V2500-A1/A5 SERIES PROPULSION SYSTEM SERVICE BULLETIN

This document transmits the Initial Issue of Service Bulletin V2500-ENG-73-0202.

ENGINE – FUEL AND CONTROL – P4.9 TUBE ASSEMBLIES, PRESSURE CONTROL AND BOX AND CABLE,
TC – REPLACE THE P4.9 TUBE ASSEMBLIES TO PREVENT FRACTURES AND REPOSITION THE EXHAUST
GAS TEMPERATURE (EGT) CABLE TO PREVENT CHAFING

IDENTIFICATION OF THE MODIFIED TURBINE EXHAUST CASE GROUP
FIGURE 17

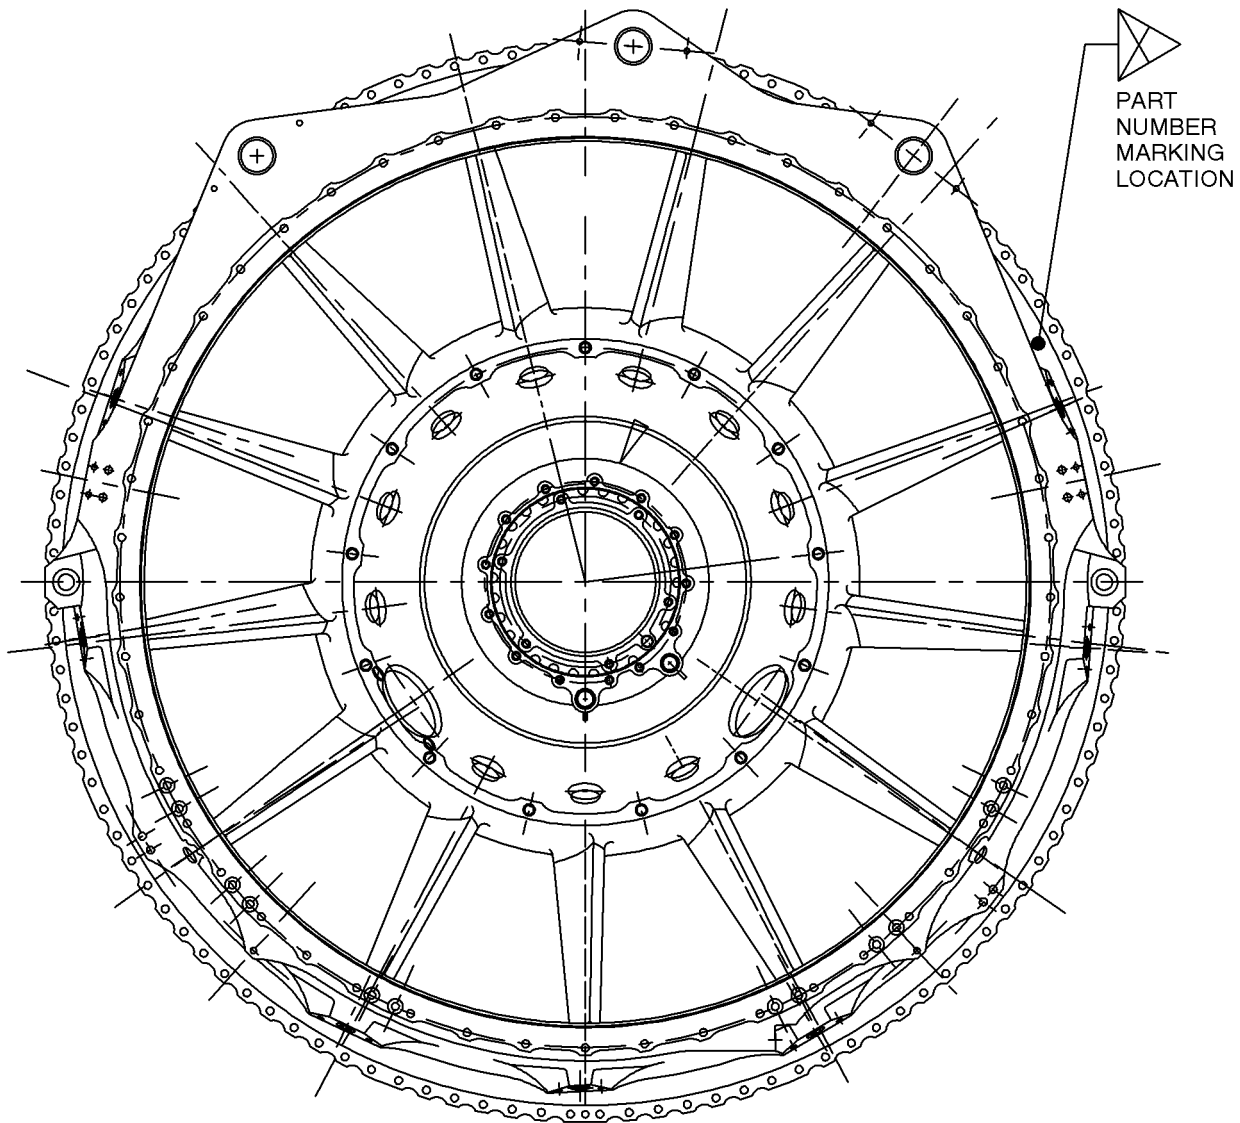
- (4) Identify the turbine exhaust case group as shown in Table 2. Mark the new part number as specified in Reference 11, Standard Practices Manual, Chapter/Section 70-09-00, vibration peen method. Mark the part number in the same location of the existing part number and maintain the same serial number. See Figure 17 for the location of the marking.
